Table A
DPE Preliminary Issues Report Responses

VICKERY EXTENSION PROJECT
Conceptual Project Rail Spur Design
Predicted Flooding Impacts

Figure 1

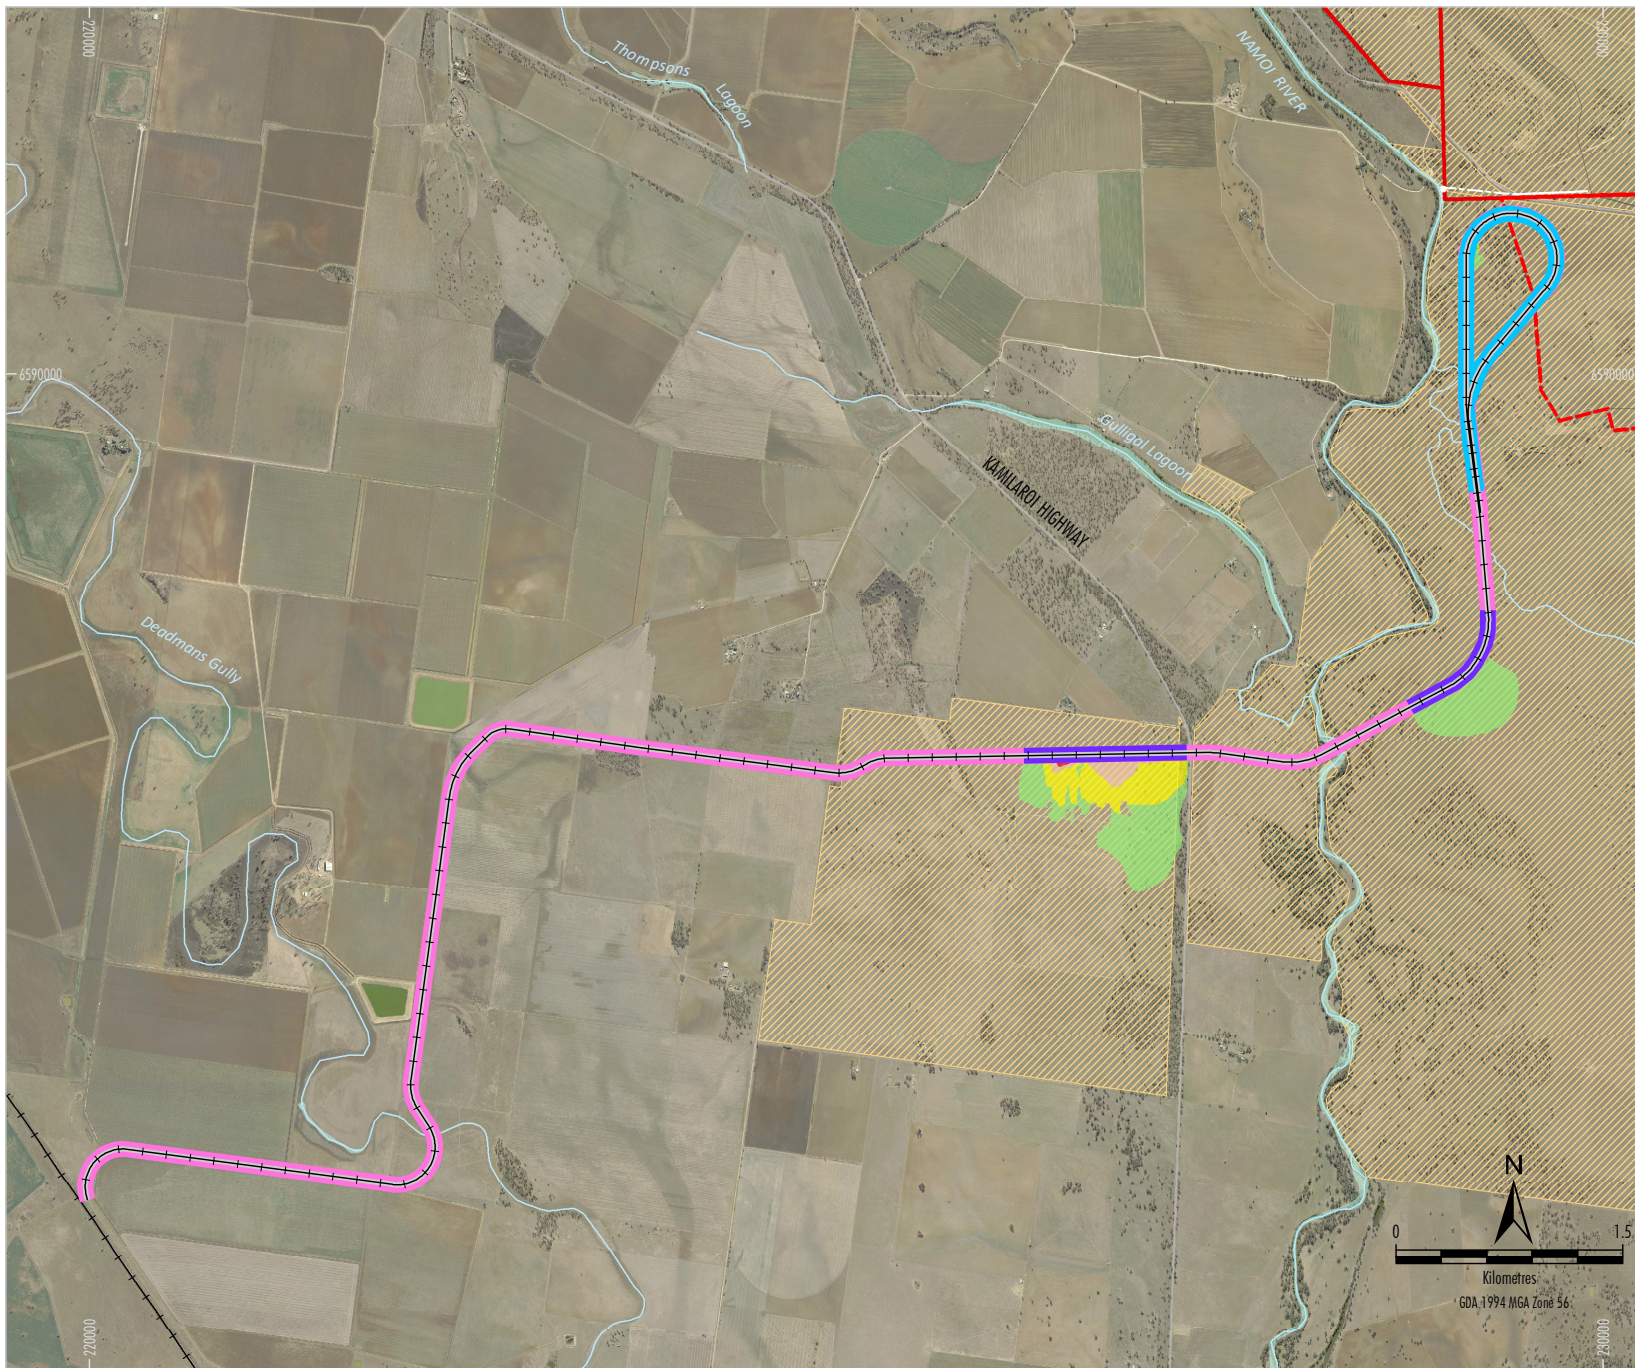
Recommendation	Response
PROJECT RAIL SPUR - FLOODING		
1	<p>In the Preliminary Issues Report, DPE states “... Ms Askew considers that some aspects of the assessment are not adequately documented and/or addressed, and has recommended additional information be provided on a number of matters to confirm and clarify the conclusions” (this includes detail on the structure of the spur [i.e. location of culverts and embankments]).</p>	<p>DPE’s Independent Peer Reviewer for flooding (Erin Askew of WMAwater) stated:</p> <p align="center"><i>The peer review has determined that the assessment is generally undertaken in accordance with industry best practice ...</i></p> <p>This statement supports the conclusions of the Project Flood Assessment (prepared by WRM) as well as the findings of the independent Peer Reviewer engaged by Whitehaven (Royal HaskoningDHV).</p> <p>The objective of the flood modelling included in the EIS was to demonstrate that the proposed location of the Project rail spur would comply with the design objectives of the <i>Draft Floodplain Management Plan for the Upper Namoi Valley Floodplain 2016</i> (Draft FMP) and the <i>Carroll to Boggabri Floodplain Management Plan 2006</i> (Department of Natural Resources, 2006) (FMP), which includes impacts to flood levels, velocities and distributions on privately-owned land.</p> <p>Initial conceptual design decisions involved elevating the Project rail spur above predicted flood levels (i.e. a superstructure supported on either pylon-like structures or in-filled embankment sections) and conceptually locating openings to provide for minimal impact to existing flooding regimes. Proceeding with a conceptual design involved an iterative approach during flood modelling, whereby the distribution of openings under the superstructure of the Project rail spur was adjusted to achieve consistency with the Draft FMP (Figure 1).</p> <p>The Project rail spur construction materials would be determined during detailed design, including consideration of constructability of the superstructure. Notwithstanding, as the superstructure is elevated clear of predicted flood levels, the ultimate composition of the Project rail spur does not impact on the flood assessment.</p> <p>The flood modelling objective was achieved as the conceptual design, incorporating the design aspects outlined above, modelled for the EIS demonstrated compliance with the objectives of the Draft FMP and negligible changes to flood levels, velocities and distributions on privately-owned land.</p>

Recommendation	Response
		<p>Subsequently, further design development of the conceptual rail spur alignment following submission of the Project EIS determined that the Project rail spur would be completely elevated on pylon-like structures west of the Namoi River. At the point where the elevated rail spur joins the Main Line embankment there will be a short transition zone. The superstructure of the rail spur would be elevated above the 1 in 100 year flood level. An example of such an elevated structure is the existing Maules Creek and Boggabri Coal Mine Rail Spur where it crosses the Namoi River floodplain (refer Plates 1a and 1b, below).</p> <p>Conceptual 3D drawings of the Project rail spur are provided in Plates 2 to 4. The conceptual drawings are consistent with the revised conceptual design (i.e. completely elevated west of the Namoi River).</p> <p>It is noted the objectives of the FMP and Draft FMP relevant to privately-owned land are for “large design floods”, which approximate the 1 in 20 year (i.e. 5% AEP) flood event. Therefore, the Project rail spur conceptual design, which includes provision to elevate the superstructure above the 1 in 100 year (i.e. 1% AEP) flood level, is considered to be conservative and prevents impacts for flood events well above what is required by the FMP and Draft FMP.</p> <p>Consistent with industry best practice, following determination of the Project, Whitehaven will engage suitably qualified and experienced infrastructure design and construction contractors to identify the most appropriate design of the Project rail spur, in consideration of structural adequacy, constructability, cost efficiency and potential flood impacts. Whitehaven will provide DPE and OEH with the final detailed rail spur design and updated flood assessment results to confirm compliance with the objectives of the Draft FMP.</p> <p>It is standard practice for Project infrastructure to be conditioned such that detailed design (conducted post-approval) confirms that the infrastructure will achieve the predicted outcomes and/or performance measures identified during the assessment phase.</p> <p>For example, regarding the approved Kamilaroi Highway Overpass, Condition 26 of the Approved Mine Development Consent (SSD-5000) provides:</p> <p><i>The Applicant must obtain an approval under Part 8 of the Water Act 1912 for all applicable works associated with the Kamilaroi Highway overpass. The Applicant shall ensure that the design and construction of the Kamilaroi Highway overpass is consistent with the Boggabri to Carroll Flood Plain Management Plan, to the satisfaction of NOW.</i></p>

Figure 2: Namoi River and Namoi River Tributary TUFLOW models

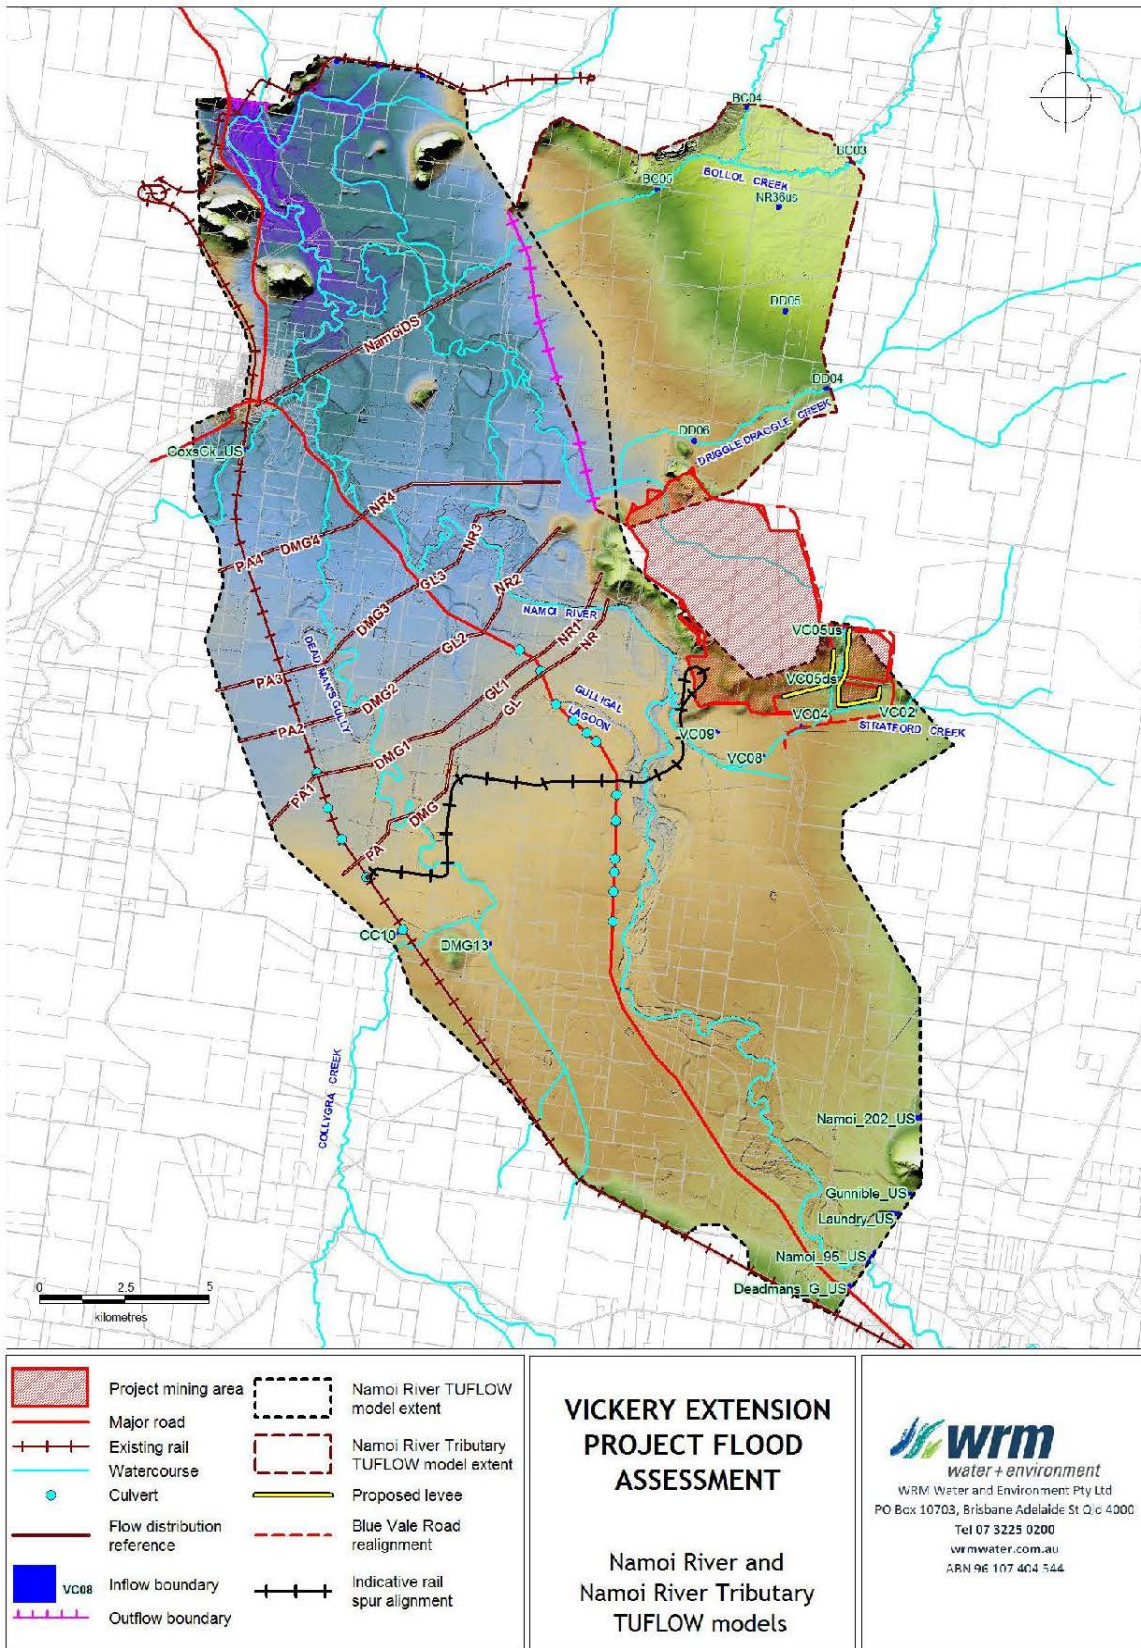
Recommendation	Response
2	<p>In the Preliminary Issues Report, DPE states “... Ms Askew also recommended further discussion to confirm the consistency of the project with the draft FMP criteria, including flow redistribution on individual properties, which is a key issue for adjacent landholders”.</p>	<p>The impact of the Project rail spur on peak flow distribution for the 5% Annual Exceedance Probability (AEP) flood event was assessed in the Flood Assessment (Section 6.4.3 of Appendix C of the EIS, reproduced below as Figure 2). The peak flow distribution impacts for the 5% AEP flood event and the 1% AEP flood event are detailed in Table 1 and Table 2, respectively (see below). The location of each Peak Flow ID is shown on Figure 6.1 of Appendix C of the EIS, reproduced below.</p> <p>The results show that the distribution of flow across the floodplain is not significantly altered by the Project rail spur for both events and would not result in a consequential effect to neighbouring properties or the environment.</p>

Figure 3

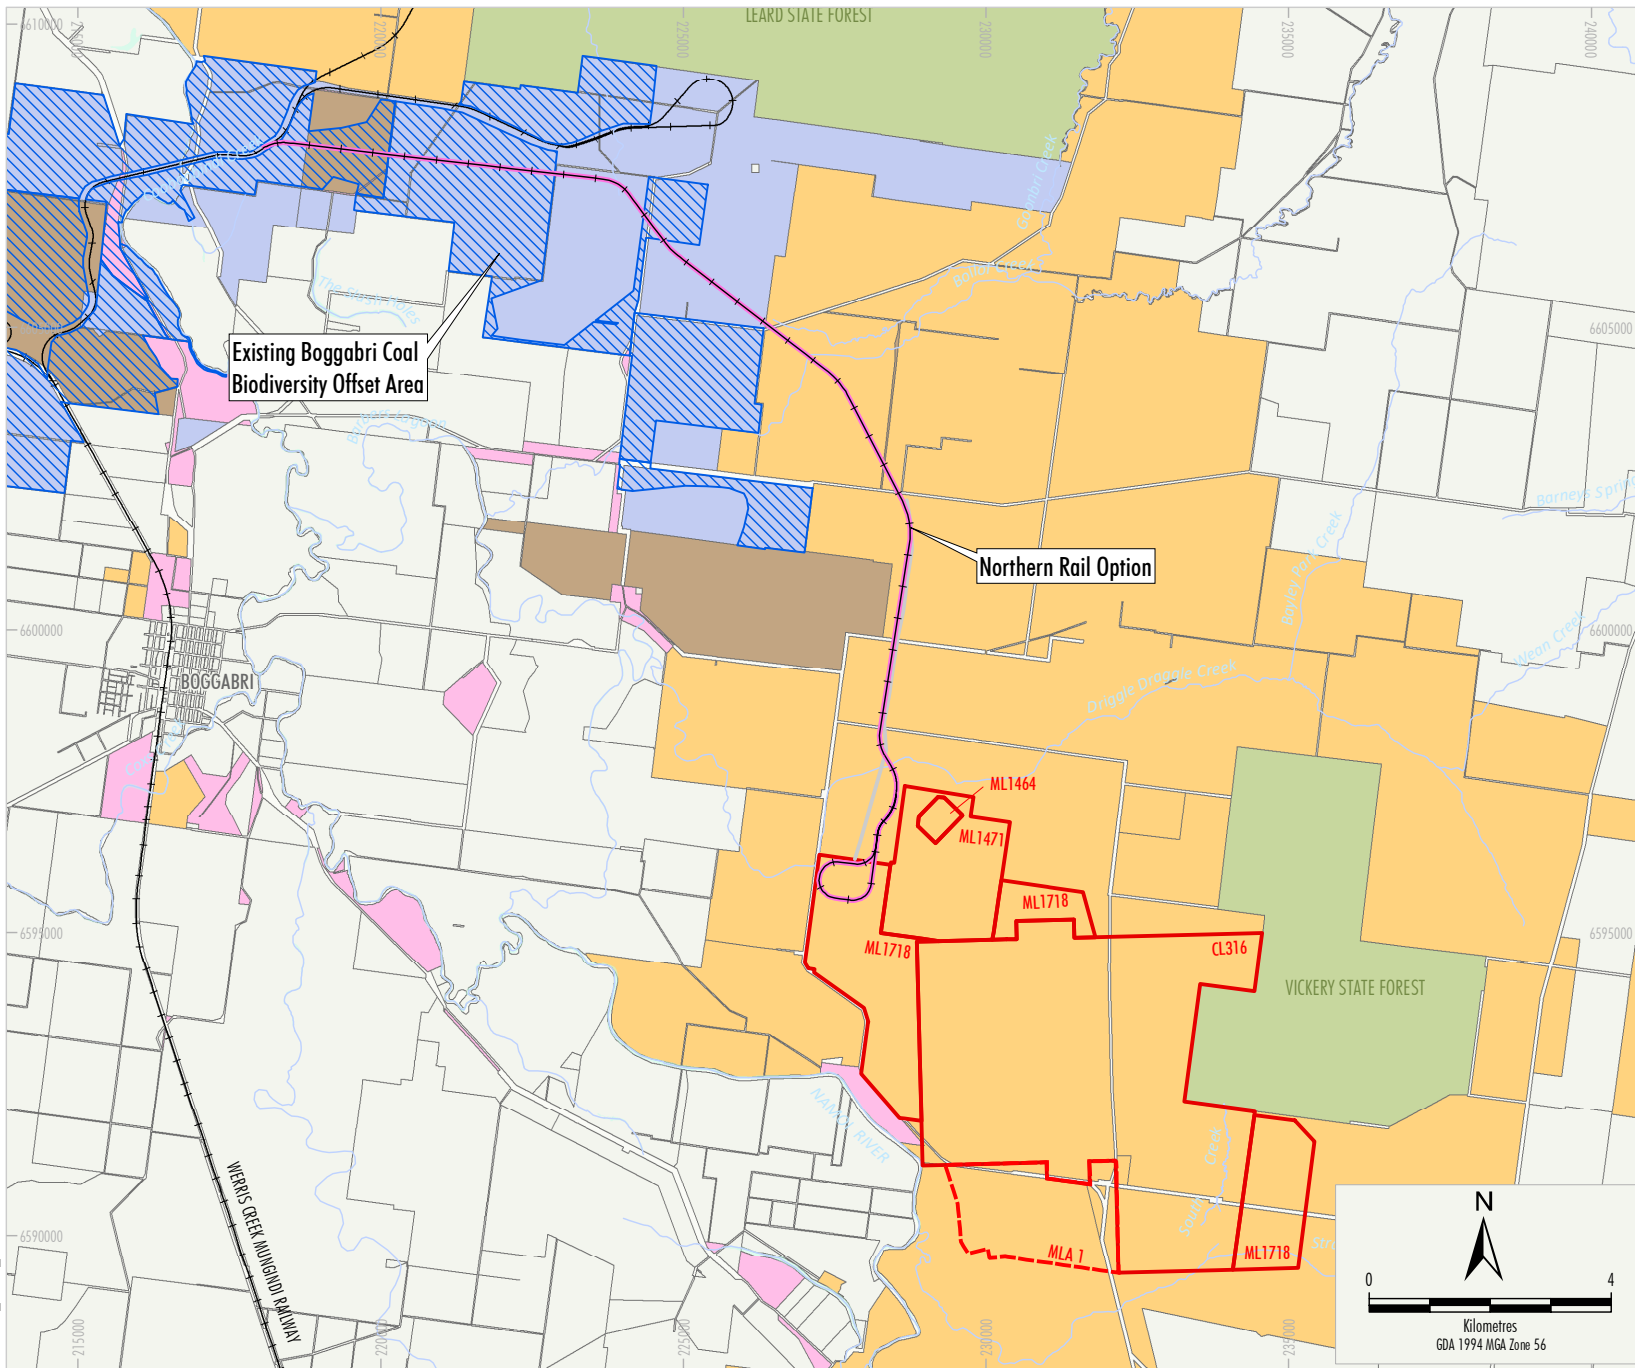
Recommendation	Response
3	<p>In the Preliminary Issues Report, DPE states “... <i>Some submitters have suggested that Whitehaven should avoid building the rail spur on the floodplain altogether, and instead extend the rail line north to the existing spur servicing the Maules Creek and Boggabri mines.</i></p> <p><i>... the Department believes that the benefits and costs/impacts of the project rail spur should be considered further in detail in the assessment of the project.”</i></p>	<p>An analysis of potential rail spur alignments (i.e. northern rail option versus Project rail spur alignment) was conducted in the EIS (Section 6.1.8 of the EIS).</p> <p>Whitehaven considers the Project rail spur provides the superior outcome for the Project, given the following:</p> <ul style="list-style-type: none"> • Private land access: <ul style="list-style-type: none"> – Whitehaven does not own all private land required for the northern rail option (Figure 3), whereas Whitehaven owns all private land required for the Project rail spur (or a land access agreement is already in place). • Logistics and congestion on the common section of the existing Maules Creek-Boggabri rail spur: <ul style="list-style-type: none"> – The Common Section of the Maules Creek-Boggabri rail spur has six participants in the joint venture (one of which is Whitehaven). – Whitehaven has a share of the capacity of the Maules Creek-Boggabri rail spur commensurate with its percentage of ownership. – At the time the original joint venture was formed, the capacity of the Common Section of the Maules Creek-Boggabri rail spur was 28 Mtpa. The Maules Creek Coal Mine has approval to rail 12.4 Mtpa and the Boggabri Coal Mine has approval to rail 10 Mtpa (i.e. 5.6 Mtpa remaining capacity). – The Project proposes the rail transport of up to 11.5 million tonnes per annum (Mtpa) run-of-mine (ROM) coal (inclusive of coal from the Rocglen and Tarrawonga Coal Mines). – This would create congestion on the common section of the existing Maules Creek-Boggabri rail spur and the adjacent section of the Werris Creek Mungindi Railway (the Main Line) unless new passing loop(s) are constructed and additional train units purchased. An additional crossing of the floodplain may also be required. – Given these constraints to the feasibility of this option, the Project rail spur alignment was progressed.

Recommendation	Response
		<ul style="list-style-type: none"> - Notwithstanding, when considering both capital and operational costs over the life of the Project, the economic advantage of the Project rail spur over the northern rail option is in excess of \$150 million NPV due to: <ul style="list-style-type: none"> ▪ increased fuel consumption and other operational costs associated with additional distance travelled by coal trains (approximately 30 km each way when travelling to the Project via the Maules Creek-Boggabri rail spur); ▪ ongoing fees to access the common section of the Maules Creek-Boggabri rail spur; ▪ Main Line passing loop construction costs; ▪ additional train unit costs; ▪ further land acquisition and agreement costs; and ▪ establishment of additional biodiversity offsets for the Boggabri Coal Mine. <p>The potential impacts of the Project rail spur alignment were assessed in the EIS with regard to flooding, land use and amenity, as summarised below.</p> <p><u>Flooding</u></p> <ul style="list-style-type: none"> • Flood modelling demonstrates negligible impact to flood levels, velocities and flow distribution beyond Whitehaven-owned land (see Figure 1) and compliance with objectives of the Draft FMP and FMP at all privately-owned properties. • Further design of the conceptual rail spur alignment, undertaken since submission of the Project EIS, has determined that it will be constructed completely on pylon-like structures on the western side of the Namoi River. An indicative view from 500 m of the conceptual rail spur is provided in Plate 5. • The results of the Flood Assessment would be reviewed following detailed design of the Project rail spur to confirm compliance with the objectives of the Draft FMP and the impacts presented in the EIS. <p><u>Land use</u></p> <ul style="list-style-type: none"> • The Project rail spur is located on land owned by Whitehaven, or where an existing access agreement is in place (see Figure 1).
